Attachment 2

COLA Revision 5 Highlighted Pages for Subsection 2.5.1 Figure RAIs

Turkey Point Units 6 & 7
COL Application
Part 2 — FSAR

Figure 2.5.1-202 Tectonic Map of the Northern Caribbean-North America Plate Boundary (Sheet 1 of 2)

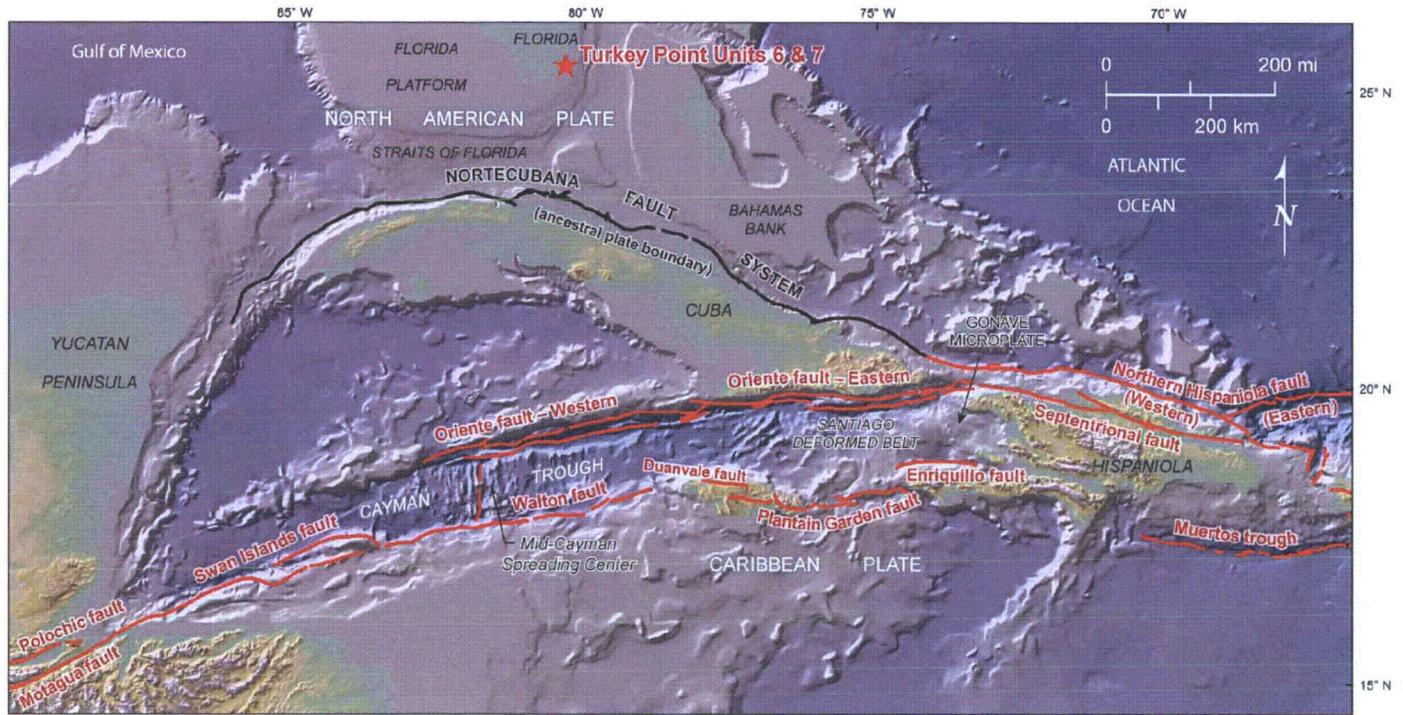
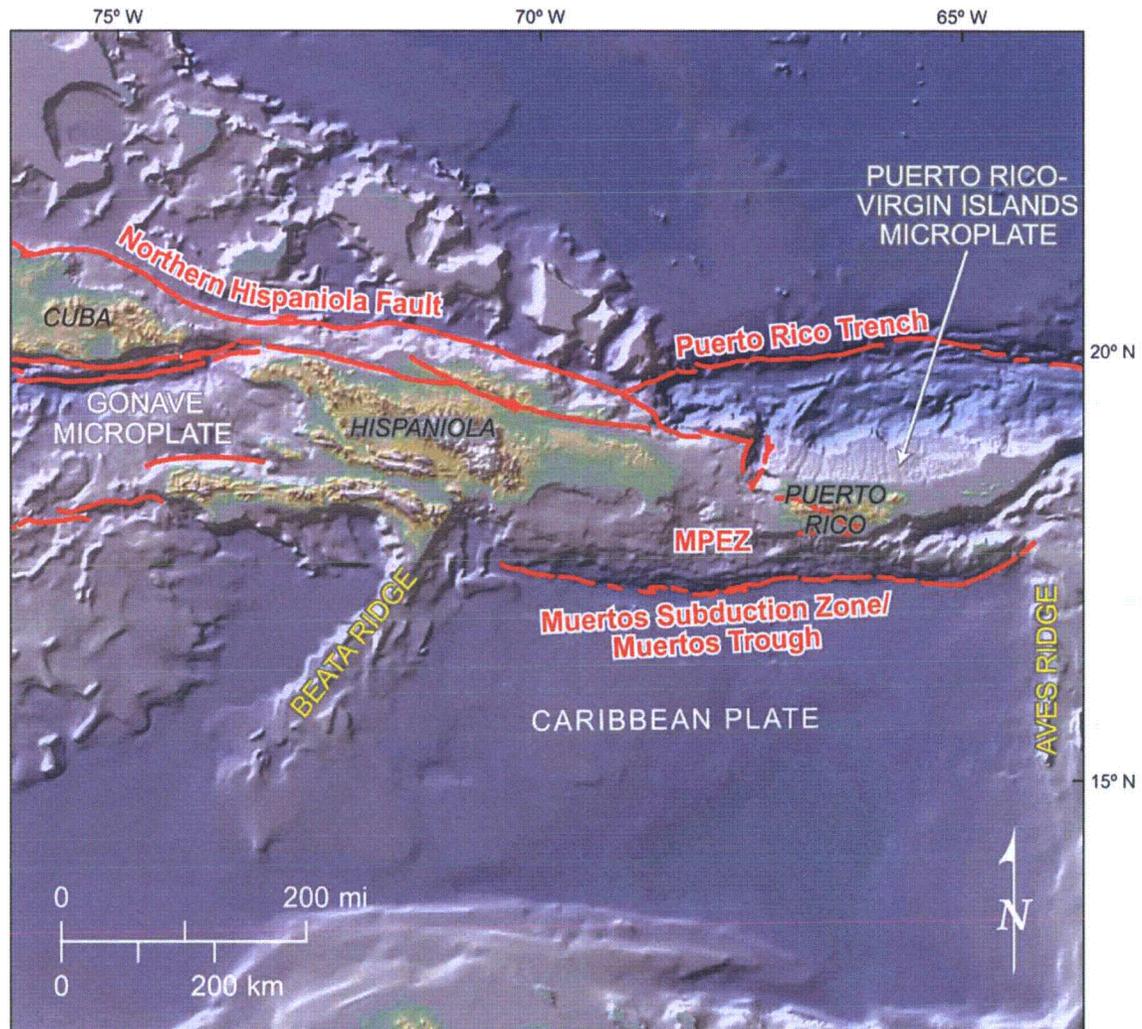
PTN RAI
02.05.01-3

Figure 2.5.1-229 Regional Tectonic Features

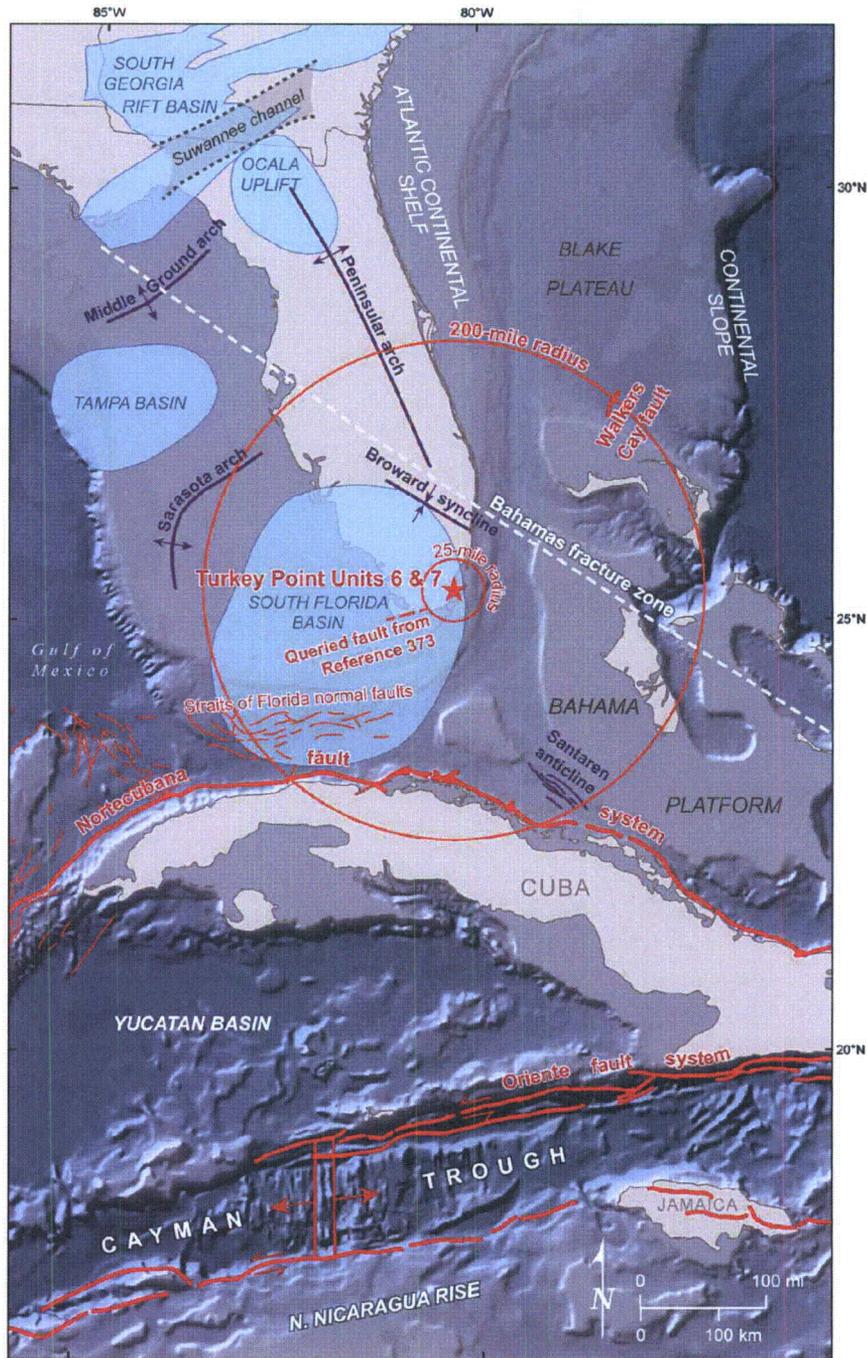
PTN RAI
02.05.01-11
PTN RAI
02.05.01-12

Figure 2.5.1-247 Tectonic Map of Cuba

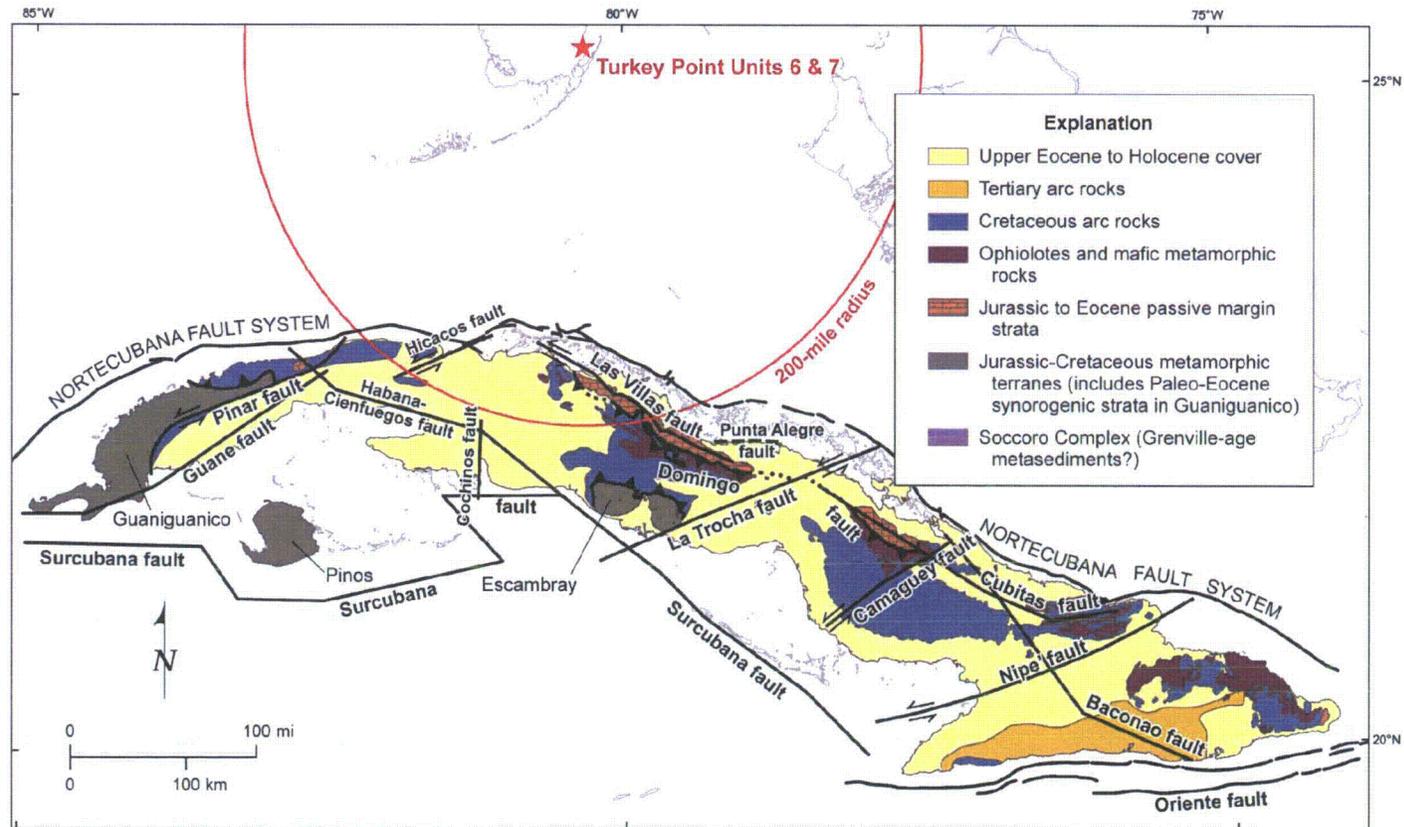
PTN RAI
 02.05.01-21
